#### Joint Meeting of Experts on the Regulations annexed to the European Agreement concerning the International Carriage of Dangerous Goods by Inland Waterways (ADN) (ADN Safety Committee)

#### Proposals for amendments to the Regulations annexed to ADN

## Explosion protection on tank vessels

### Transmitted by the Governments of Germany and Netherlands

**Alternative 1**

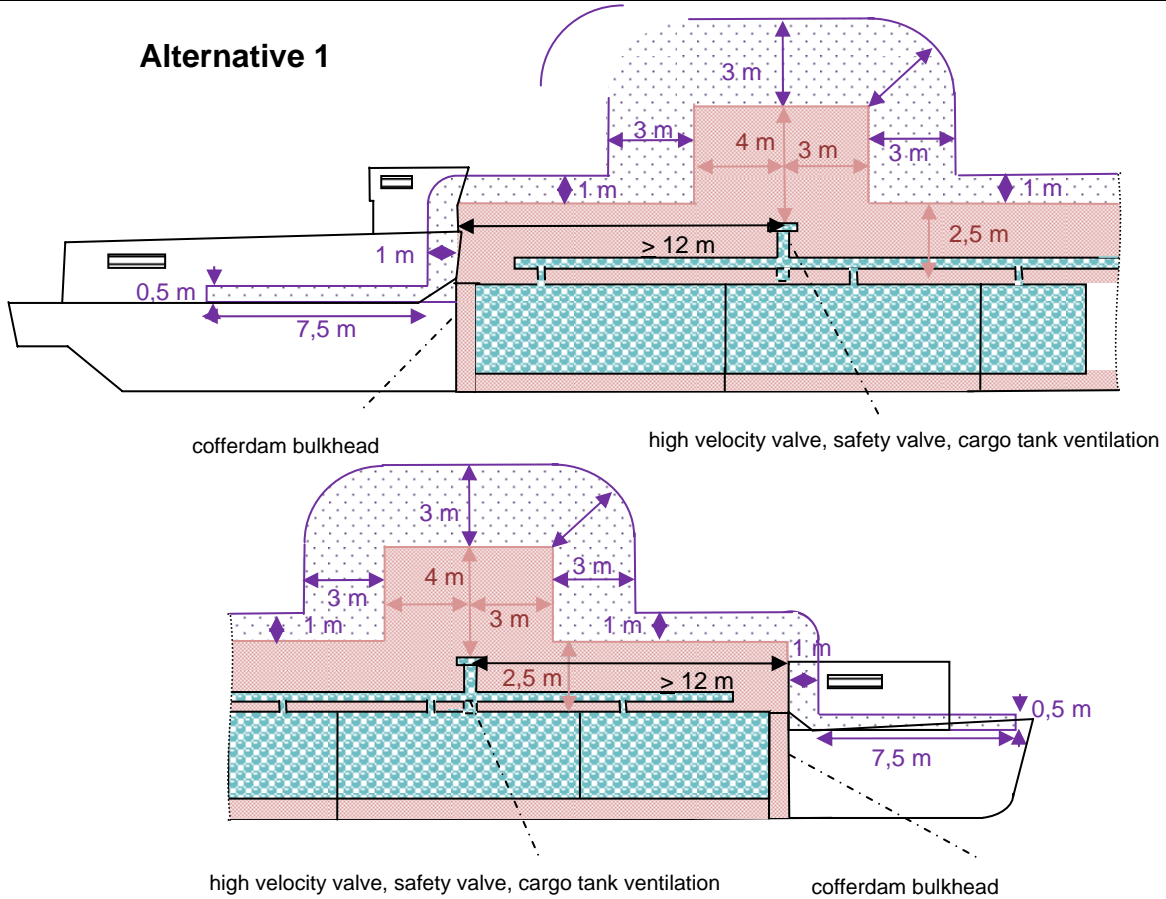
**Zone 0:**

Inside all cargo tanks, tank-containers or portable tanks, pipings containing cargoes or cargo vapours including their equipment as well as pumps and compressors.

**Zone 1:**

Inside all compartments within the part of the cargo area below deck not part of zone 0.

An area above the entire deck within the cargo area up to a height of 2.5 m as well as:

An area surrounding cylindrically the HJ/safety valves with a radius of 3.0 m up to a height of 4.0 m above the opening.

An area surrounding cylindrically the openings in zone 0 with a radius of 2.5 m up to a height of 2.5 m above the opening.

an area surrounding the ventilation openings of the service spaces located within the cargo area which are actively ventilated, comprising a radius of 1.0 m centered over the opening.

**Zone 2:**

An area of 1.0 m in height and length following zone 1.

An area of 7.5 m in length and 0.5 m in height outside the cargo area adjacent to the aforementioned zone 2.

An area following zone 1 around the HJ/safety valves having an expansion of 3.0 m.

An area following zone 1 which surrounds the ventilation openings of the service spaces located within the cargo area which are actively ventilated, comprising a radius of 1.0 m centered over the opening.

The interior of closed compartments extending into zone 2 and being constructed in such a way that the penetration of gases from zone 2 is avoided, will not be part of the explosion-hazardous area.
